Re: Florida Power & Light Company
Proposed Turkey Point Units 6 and 7
Docket Nos. 52-040 and 52-041
Response to NRC Request for Additional Information Letter No. 040 (eRAI 6006)
SRP Section - 02.05.04 Stability of Subsurface Materials and Foundations

L-2011-552
10 CFR 52.3

NRC RAI Letter No. PTN-RAI-LTR-040

SRP Section: 02.05.04 - Stability of Subsurface Materials and Foundations

Figure 2.5.4-209 Plan Showing Geotechnical Cross Section Locations

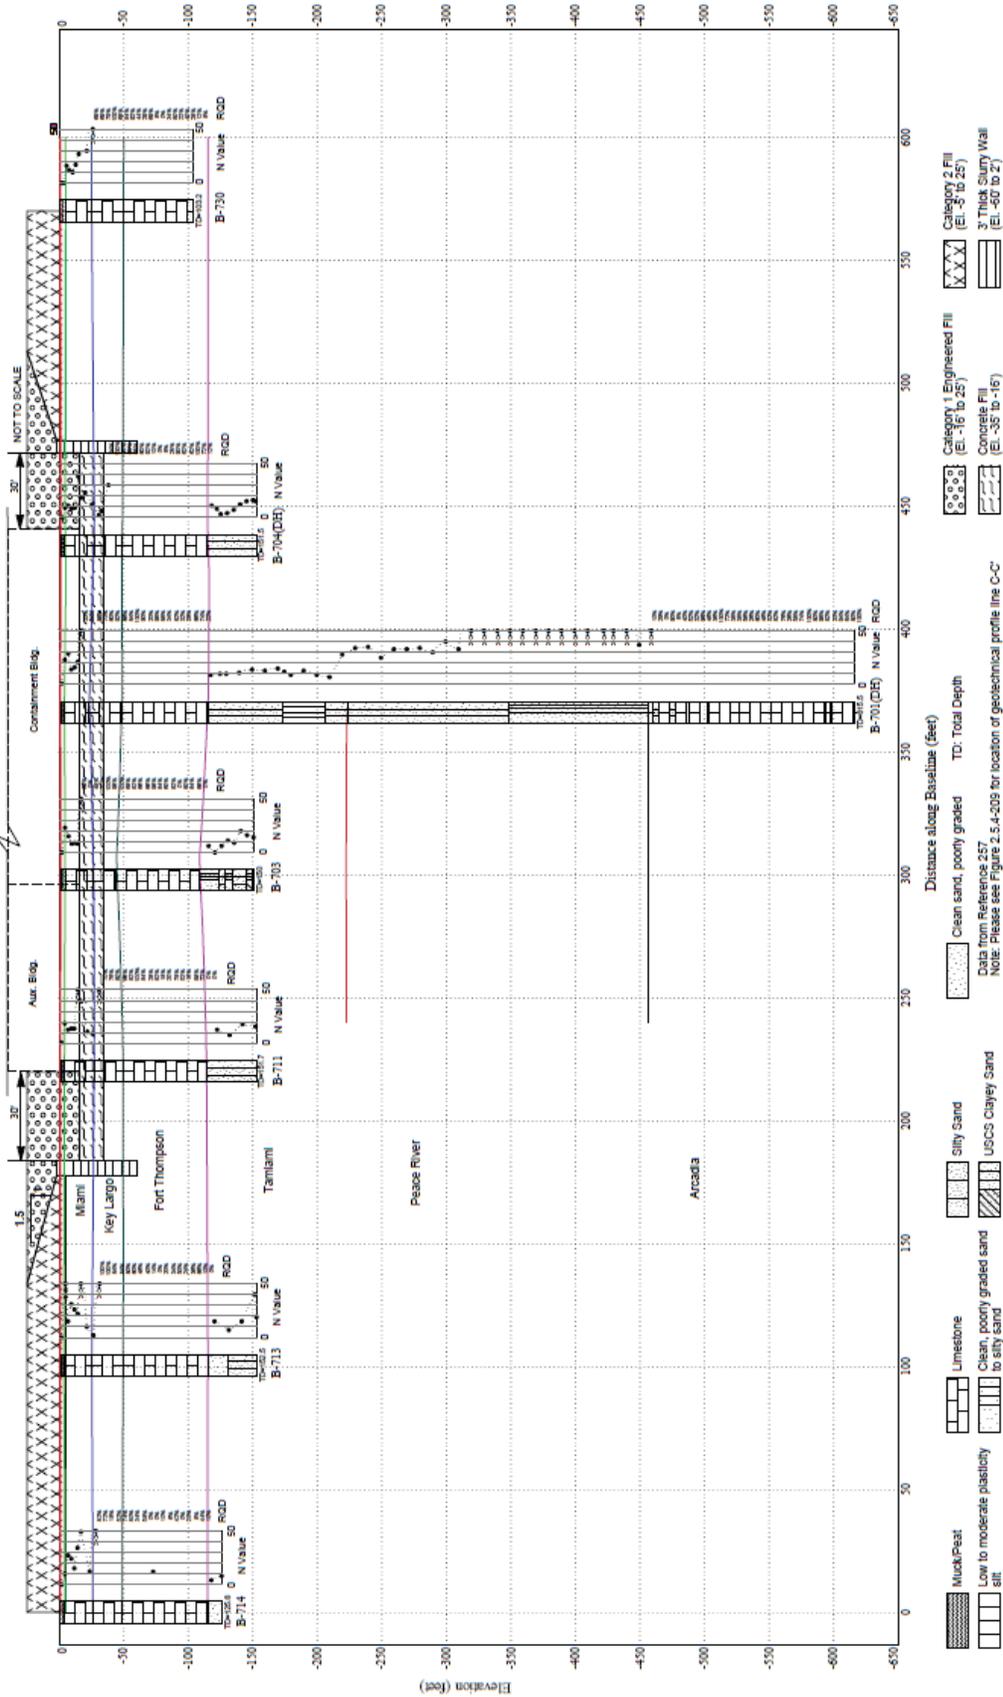
FSAR Figures 203 through 209 indicate one boring for each of the two Units extending to a depth of about 450'. Most other borings taken at the site extend to depths of only about 150'. Figure 2.5.4-220 presents information on shear wave velocity, including best estimate (BE) and upper/lower bound (UB/LB) values down to a depth of about 600'. In accordance with NUREG-0800, Standard Review Plan, Chapter 2.5.4, "Stability of Subsurface Materials and Foundations," please indicate how you estimated variations in shear wave velocity based on only two readings over the deeper portion of the profile.

FSAR Figure 2.5.4-222 shows a general conceptual excavation cross-section. In accordance with NUREG-0800, Standard Review Plan, Chapter 2.5.4, "Stability of Subsurface Materials and Foundations," please describe the procedures that will be followed during site excavation and construction activity to ensure that the appropriate strata for the proposed foundation locations are confirmed through objective measures and the exposed foundation laying surface is uniform. Also, please provide the vertical and horizontal extent of all seismic categories I excavations, fills, and slopes, including the locations and limits of excavations, fills, and backfills on plot plans and geologic sections and profiles.

The profiles from the power block subsurface investigation (refer to FSAR Figures 2.5.4-203 through 2.5.4-208) show that the subsurface strata to support foundations are relatively horizontal. However, it should be noted that the extent of excavation to final subgrade and/or to final over-excavation level is determined during construction. This determination is based on observation of actual subsurface conditions encountered, and their suitability for foundation support.

Revised FSAR Figures 2.5.4-203 through 2.5.4-209 will be included in a future FSAR revision to show vertical and horizontal extent of excavations, fill locations and slopes. Note that dimensions and slopes on figures as shown are preliminary pending final design

Figure 2.5.2-249 Median Profiles of Strain-Compatible Soil Damping (Upper 800 feet) (Sheet 2 of 2)

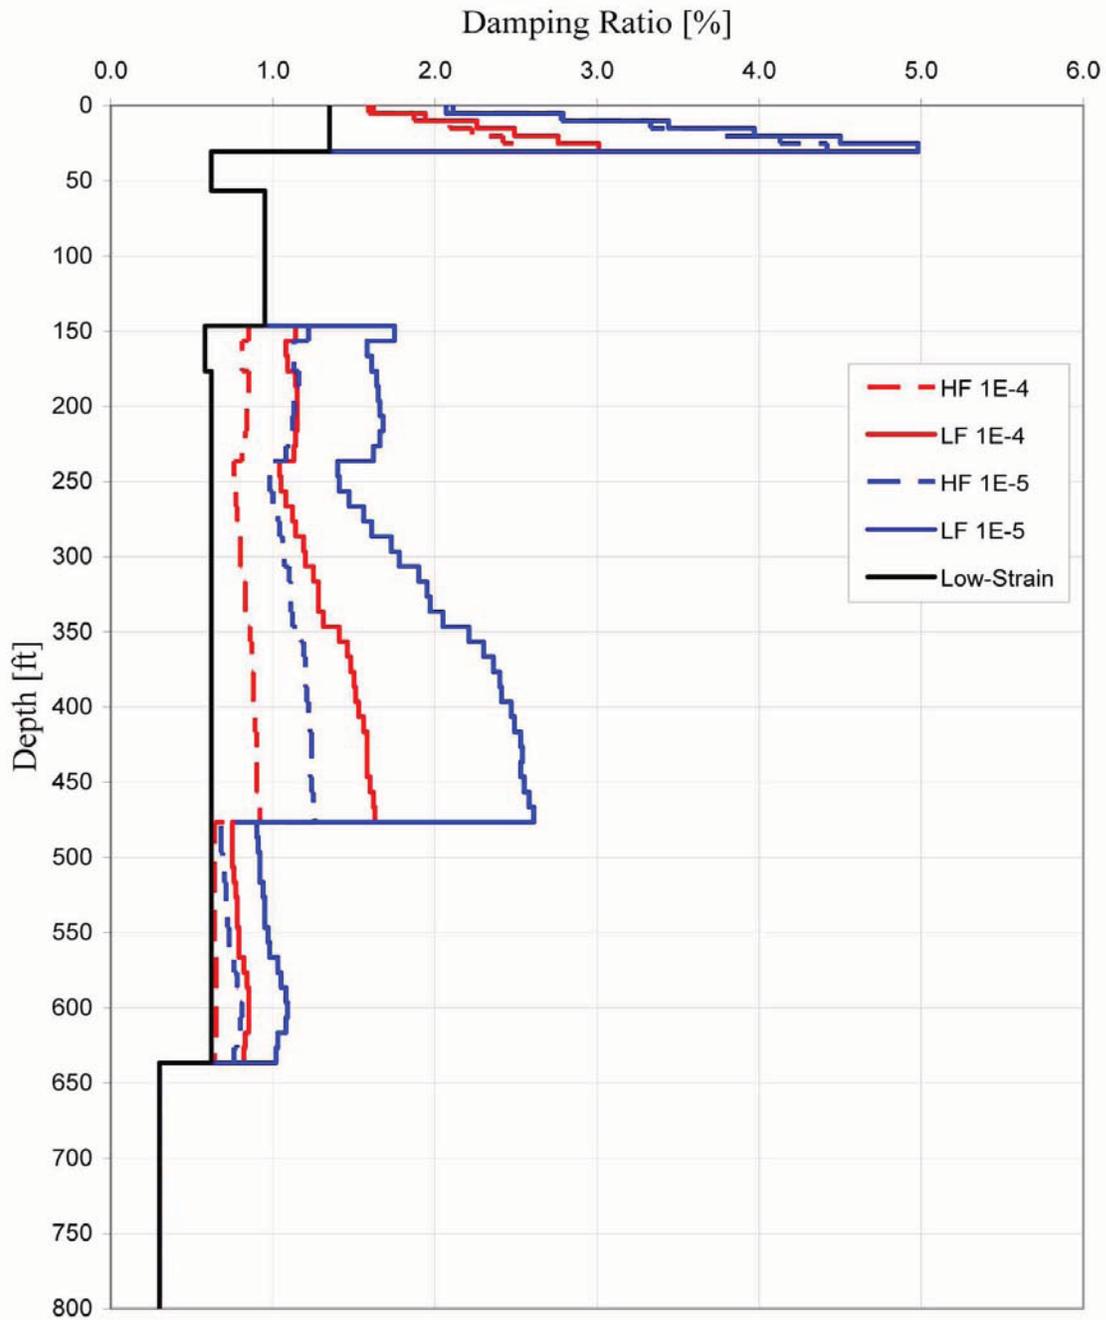
Section 2.5.4.7.3.3 "Shear modulus and Damping for Rock", indicates that the damping for rock is taken as 1%. The damping shown in Figure 2.5.2-249, which describes the soil properties used to develop the GMRS, indicates that a damping value of 0.5% was used in the analyses. In accordance with NUREG-0800, Standard Review Plan, Chapter 2.5.4, "Stability of Subsurface Materials and Foundations," please provide clarification as to the actual level of damping used in the analyses and provide a basis for its selection considering the large variability in RQD shown in Figure 2.5.4-215.

FSAR Figure 2.5.2-249 (Sheet 2 of 2) is reproduced in this response for illustrative purposes. This figure represents the full soil and rock column that includes approximately 30 ft of structural fill (with surface at El. +25.5 ft) above approximately 25 ft of Miami Limestone, overlying about 90 ft of rock consisting of the Key Largo and Fort Thompson Formations. The rock is underlain by soil of the Tamiami and Peace River Formations to about 470 ft depth. The Arcadia Formation, consisting of very weak rock mixed with some soil extends to about 640 ft depth, the limiting depth of the site subsurface investigation. The actual levels of damping used in the analyses are the values shown in FSAR Figure 2.5.2-249. The basis for selecting the value for each formation is described in the following paragraphs.

FSAR Subsection 2.5.4.7.3.3 indicates that the Miami Limestone is considered sufficiently weak to have a strain-dependent modulus and damping values. FSAR Table 2.5.4-216 shows the damping ratio (D%) versus shear strain values. D remains constant at 0.6% from 0.0001% to 0.03% strain. In the SHAKE analysis, shear strain did not exceed 0.03%, and so D is constant at 0.6% in FSAR Figure 2.5.2-249. D = 1% at all strain levels for the Key Largo and Fort Thompson Formations (Strata 3 and 4) as stated in FSAR Subsection 2.5.4.7.3.3, which notes that damping in these formations is not strain dependent.

The only other rock formation noted in FSAR Subsection 2.5.4.7.3.3 is Stratum 8, the Arcadia Formation. This formation is included with the Key Largo and Fort Thompson Formations in FSAR Subsection 2.5.4.7.3.3 as being non strain-dependent, and having D constant at 1%. The Arcadia formation is much weaker than the Key Largo and Fort Thompson Formations. FSAR Table 2.5.4-209 indicates an unconfined compressive strength of 100 psi compared with 1,500 and 2,000 psi for the Key Largo and Fort Thompson Formations, respectively. Even the strain-dependent Miami Limestone has double the strength of the Arcadia Formation. Thus, for the Arcadia Formation, consideration was given to using the D versus shear strain values of the Miami Limestone

(Oolite) given in FSAR Table 2.5.4-216. However, since the Arcadia Formation is the lower portion of the Hawthorn Group, with the overlying Peace River Formation (FSAR Subsection 2.5.1.1.2.1.1) forming the upper portion, it was considered more appropriate to use the D versus shear strain values of the Peace River Formation for the Arcadia Formation. FSAR Subsection 2.5.4.7.3.2 will be modified to indicate that the Peace River Formation damping values are also used for the Arcadia Formation. (FSAR Subsection 2.5.4.7.3.1 will be similarly modified to address shear modulus degradation curves.)

The constant damping ratio of the material below the Arcadia Formation, i.e., below about 640 ft depth in FSAR Figure 2.5.2-249, is 0.32% based on the median value of kappa and associated uncertainty.

Figure 1. 5% Damping ARS at Ground Surface – Near NI, Envelope of LF and HF

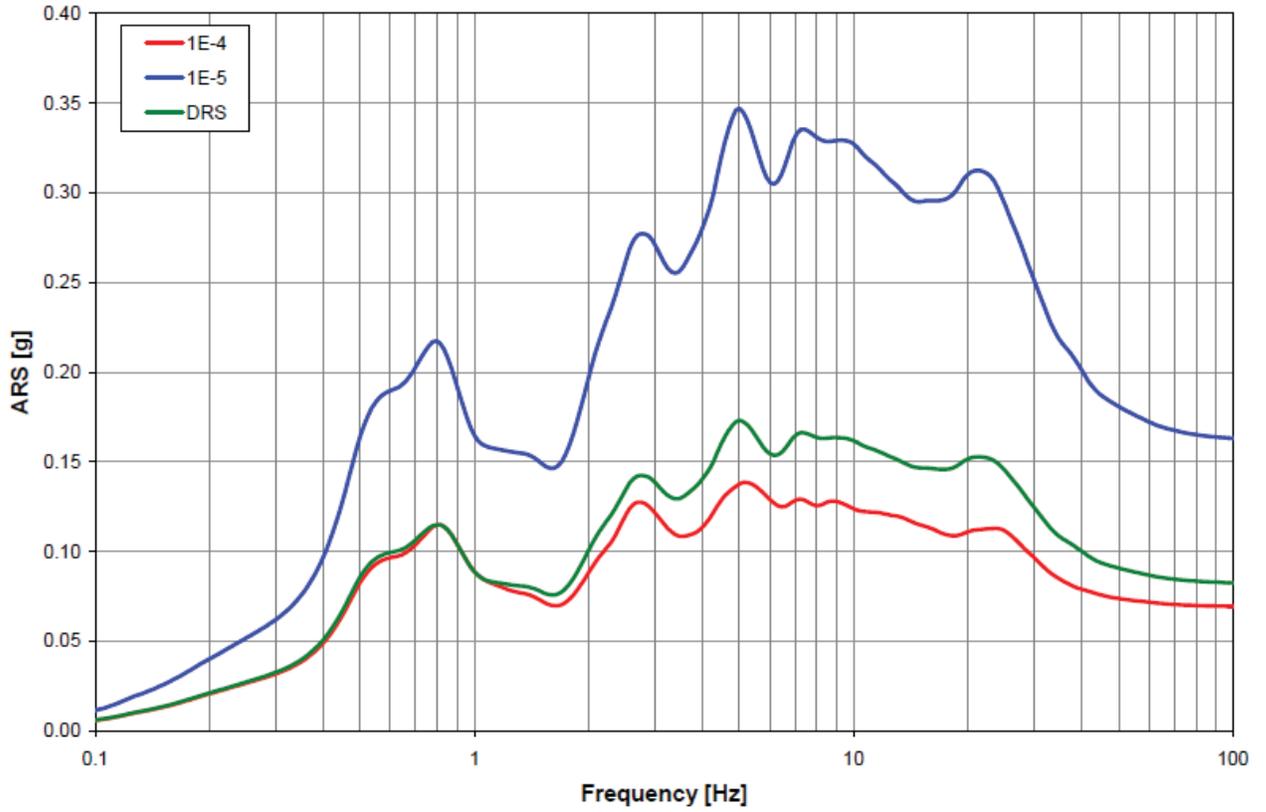
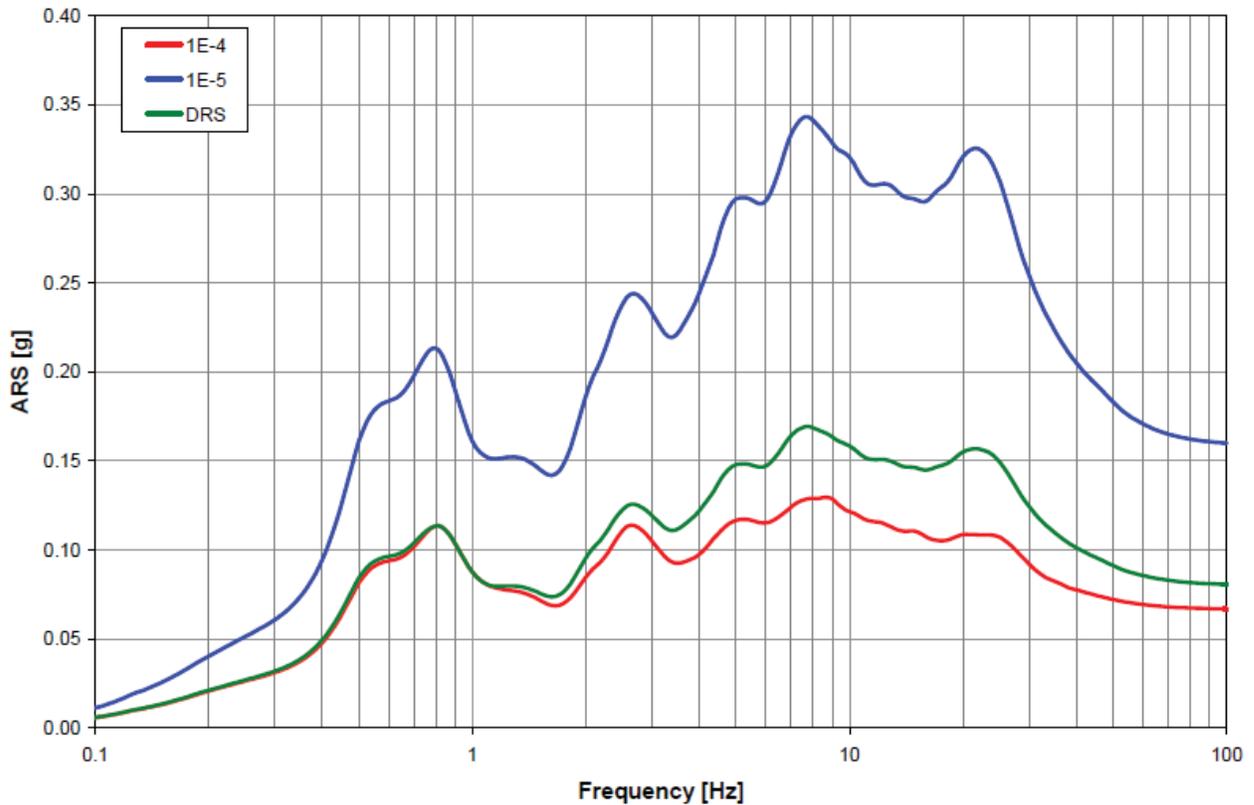
The lateral earth pressure diagram shown in Figure 2.5.4-240 shows a plot corresponding to the dynamic lateral earth pressure. The shape of this plot appears to be consistent with the shape for dynamic pressure considering a rigid structural wall (see ASCE 4). In Section 2.5.4.10.4.2 "Seismic Lateral Earth Pressures", the active seismic pressure was computed using the Mononobe-Okabe equation. The last sentence of the section indicates that at-rest pressure as a function of depth for below-grade walls is developed consistent with Reference 277 (ASCE-4) using the design ground motion. It is noted that the pressure developed using the ASCE-4 methodology uses the z_{pa} value from the input motion.

Figure 2.5.2-252 shows the input motion (GMRS) developed for the site, the GMRS is located at Elevation 35 [sic]. In this Figure the z_{pa} is approximately 0.058g. However, the elevation of the GMRS is considerably lower than the surface of the soils adjacent to the basement walls that are to be evaluated for seismic lateral earth pressure. In accordance with NUREG-0800, Standard Review Plan, Chapter 2.5.4, "Stability of Subsurface Materials and Foundations," please clarify on the definition of the design ground motion, and how that motion is consistent with Appendix S to 10CFR50.

The Design Response Spectra (DRS) at 5% damping are calculated at the ground surface for the near Nuclear Island (NI) and far from NI soil sites using the envelope of low frequency (LF) and high frequency (HF) acceleration response spectra (ARS) at 10^{-4} and 10^{-5} annual probability of exceedance. These ARS envelopes and the DRS are plotted in Figures 1 and 2 for the near NI and far from NI soil sites, respectively. From Figures 1 and 2, the peak ground acceleration at the ground surface is equal to approximately 0.0824g and 0.0806g (DRS at 100 Hz) for the near NI and far from NI soil sites, respectively.

Regarding the computation of active seismic pressure using the Mononobe-Okabe equation, according to Whitman (1991), use of horizontal ground acceleration for design at the base level of the wall may result in underestimating the movements; it seems best to use the acceleration at the surface of the backfill, or an average between the surface and the base of the wall. Thus, an acceleration of 0.1g, rather than the peak ground acceleration of 0.0824g (near NI) or 0.0806g (far from NI), is conservatively used in the Mononobe-Okabe equation.

Similarly, for the computation of at-rest seismic pressure using the ASCE 4-98 method, an acceleration of 0.1g, rather than the peak ground acceleration of 0.0824g (near NI) or 0.0806g (far from NI), is conservatively used.
